State of Ohio Environmental Protection Agency

RE: Battelle Memorial Institute, West Jefferson Decontamination and Decommissioning (D&D) Comments and Recommendations

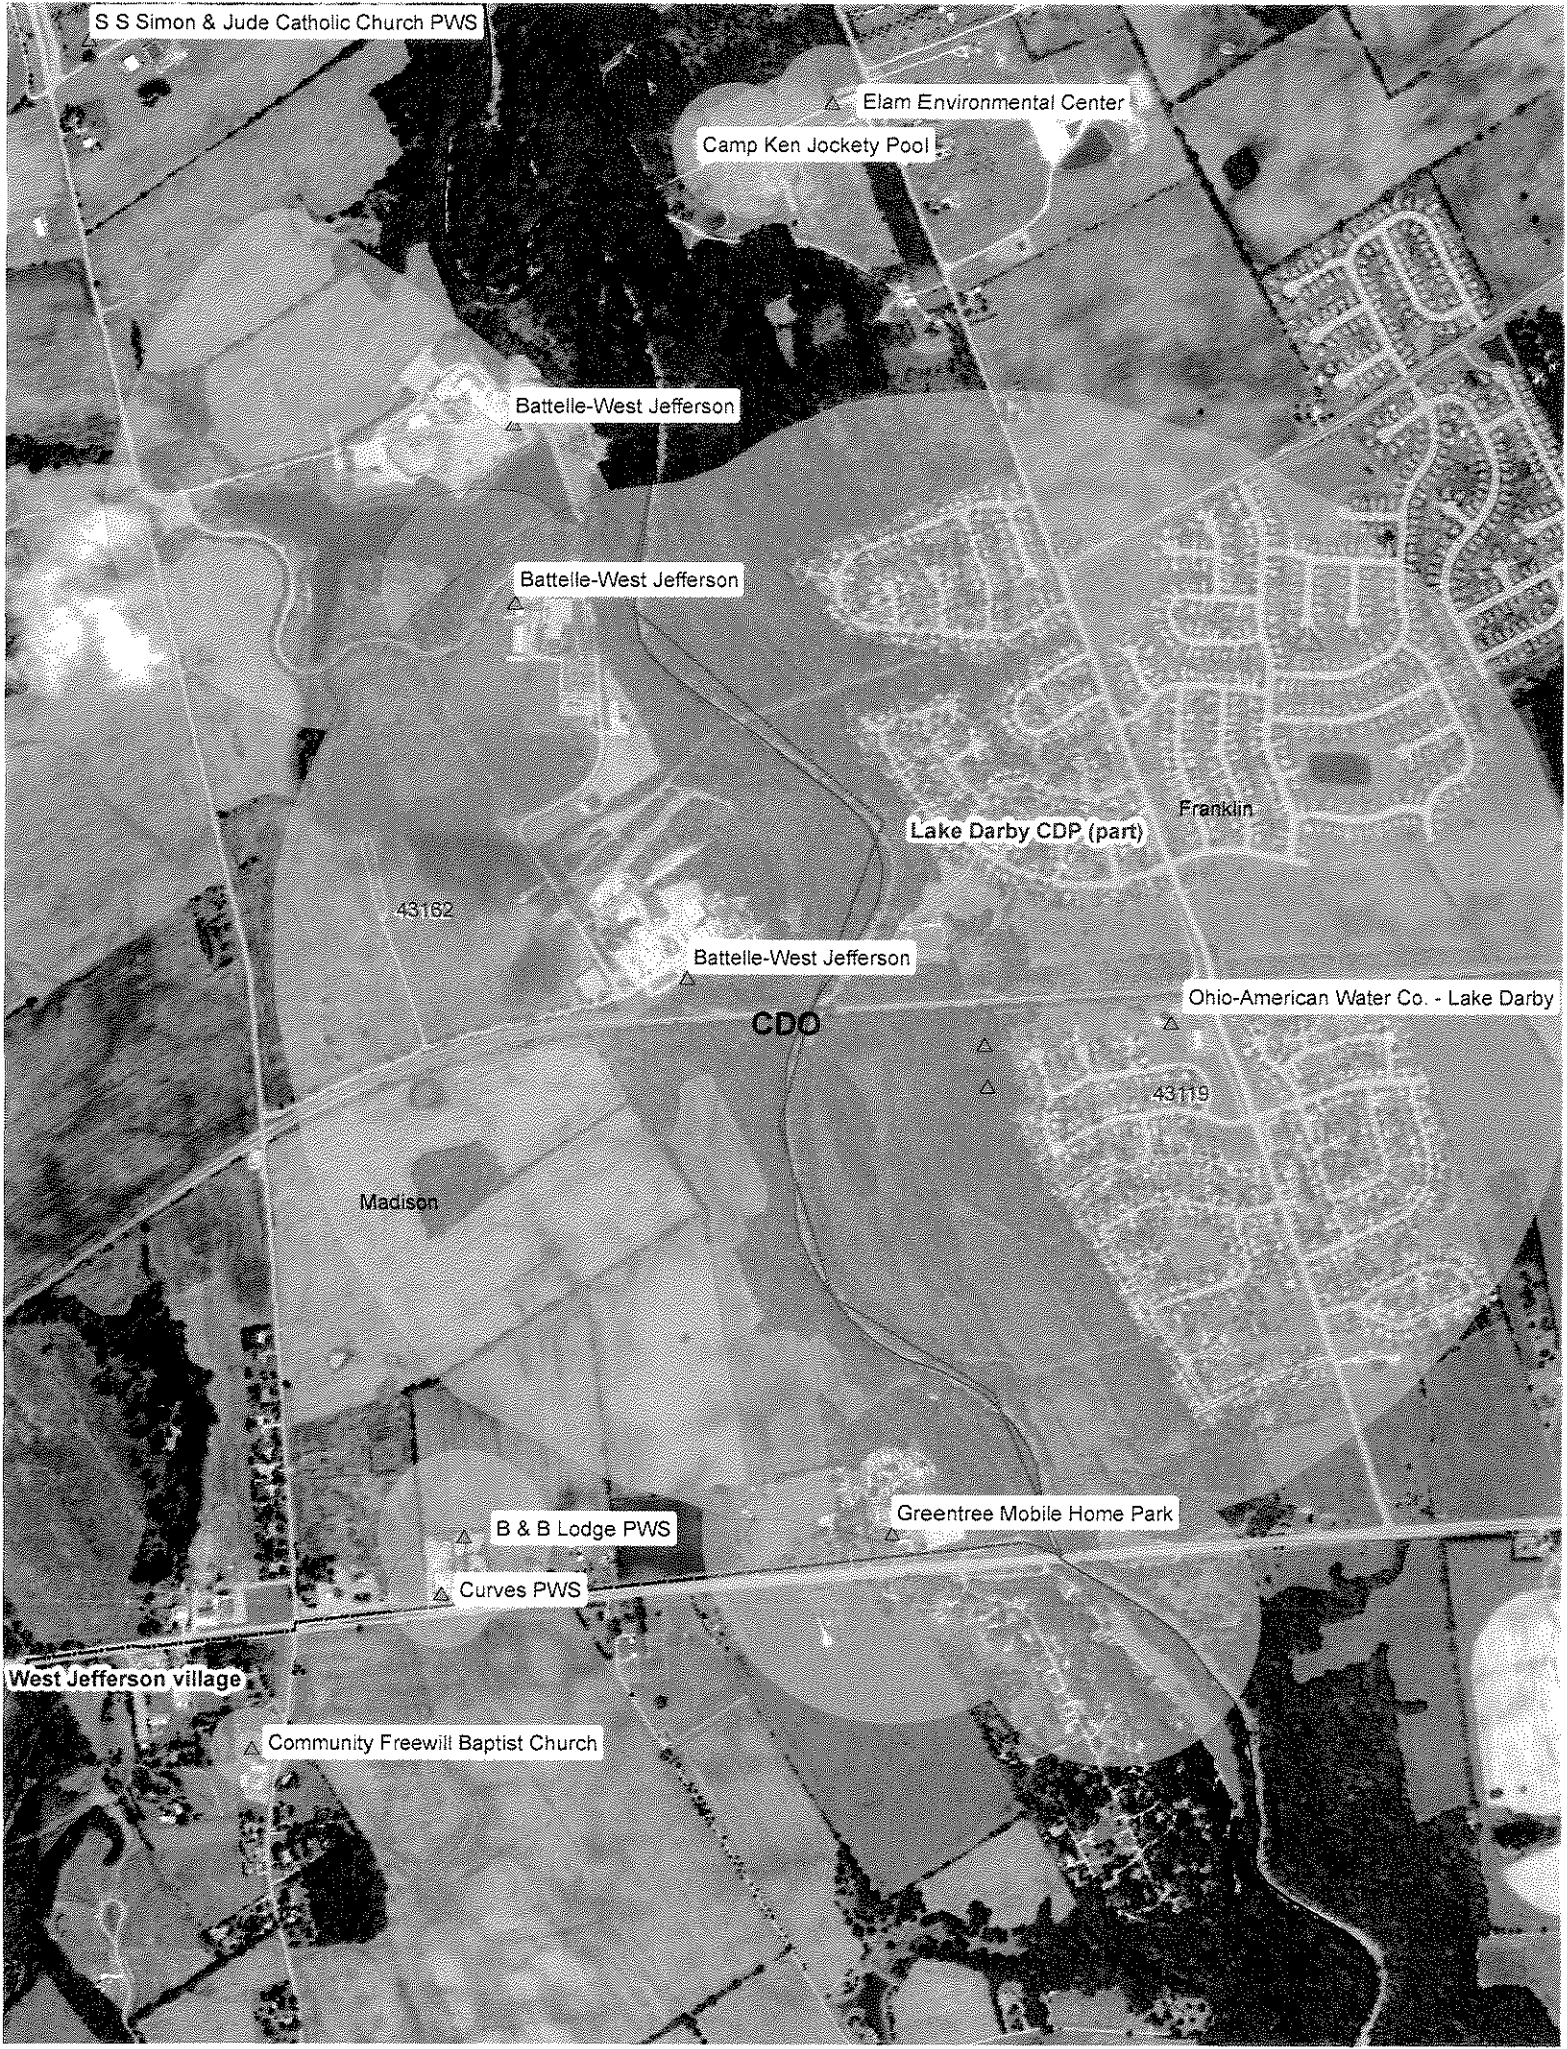
Our second concern is that approximately 5,000 residents all are within one mile of the Battelle campus and drink water from wells (Attachment). A well log search of the Ohio Department of Natural Resources records revealed over 90 public and private wells within one mile of Battelle. Twenty nine (29) of these wells are completed in sand and gravel aquifers. Eleven (11) of these wells draw from sand and gravel aquifers that are equal to or shallower than the depth of the contaminated Bog Area. We are concerned that this demonstrates how the shallow sand and gravel aquifers in the area (which are currently source of drinking water) may be at risk.
